Access Compliance Report Public Rights-of-Way (Island Curb Cuts)

Main Street: CARBON_CANYON_RD Cross Street: VALENCIA_AVE Location: SE

ADA ID: CCRK220201121941 Curb Cut Type: IslandRefuge3 Initial Pass/Fail: Pass Overall Compliance: No Severity Score: 25

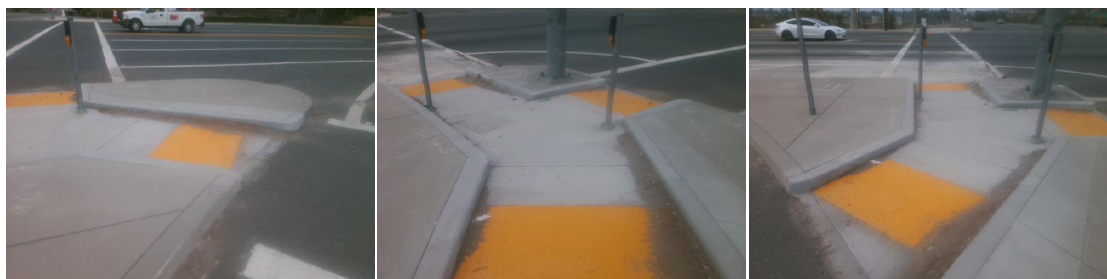
**Remove & Replace Detectable Warning System.
Utility Present.**

Compliance	Description	Data	Compliance	Description	Data
Yes	Refuge 1 Length (In)	53	Yes	Guttter 1 Ponding	No
Yes	Refuge 1 Width (In)	61	Yes	Gutter 1 Lip Ht (In)	0
Yes	Refuge 1 Slope (%)	0.6	Yes	Gutter 1 Slope (%)	1.9
Yes	Refuge 1 Cross Slope (%)	0.4	Yes	Gutter 1 Cross Slope (%)	1
N/A	Painted Cross Walk 1	Yes	Yes	DWS 1 Provided	Yes
	Cross Walk 1 Direction	N	Yes	DWS 1 Contrast	Yes
	Cross Walk 1 Width (In)	144	Yes	DWS 1 Length (In)	36
Yes	Refuge Inside Cross Walk 1	Yes	Yes	DWS 1 Full Width	Yes
	Road 1 Slope (%)	2.9	No	DWS 1 Offset (In)	4
	Road 1 Cross Slope (%)	0.5			
Yes	Refuge 2 Length (In)	98	Yes	Guttter 2 Ponding	No
Yes	Refuge 2 Width (In)	61	Yes	Gutter 2 Lip Ht (In)	0
Yes	Refuge 2 Slope (%)	3.7	Yes	Gutter 2 Slope (%)	1.4
Yes	Refuge 2 Cross Slope (%)	0.9	Yes	Gutter 2 Cross Slope (%)	1.9
N/A	Painted Cross Walk 2	Yes	Yes	DWS 2 Provided	Yes
	Cross Walk 2 Direction	W	Yes	DWS 2 Contrast	Yes
	Cross Walk 2 Width (In)	144	Yes	DWS 2 Length (In)	36

Yes	Refuge Inside Cross Walk 2	Yes	Yes	DWS 2 Full Width	Yes
	Road 2 Slope (%)	0.4	No	DWS 2 Offset (In)	6
	Road 2 Cross Slope (%)	1.4			
Yes	Refuge 3 Length (In)		Yes	Guttter 3 Ponding	No
Yes	Refuge 3 Width (In)	61	Yes	Gutter 3 Lip Ht (In)	0
Yes	Refuge 3 Slope (%)	0.8	Yes	Gutter 3 Slope (%)	0.3
Yes	Refuge 3 Cross Slope (%)	0.8	Yes	Gutter 3 Cross Slope (%)	0.1
N/A	Painted Cross Walk 3	Yes	Yes	DWS 3 Provided	Yes
	Cross Walk 3 Direction	SE	Yes	DWS 3 Contrast	Yes
N/A	Cross Walk 3 Width (In)	144	Yes	DWS 3 Length (In)	36
Yes	Refuge Inside Cross Walk 3	Yes	Yes	DWS 3 Full Width	Yes
	Road 3 Slope (%)	2.9	No	DWS 3 Offset (In)	16
	Road 3 Cross Slope (%)	0.1			
Yes	Overall Surface Condition:	Acceptable
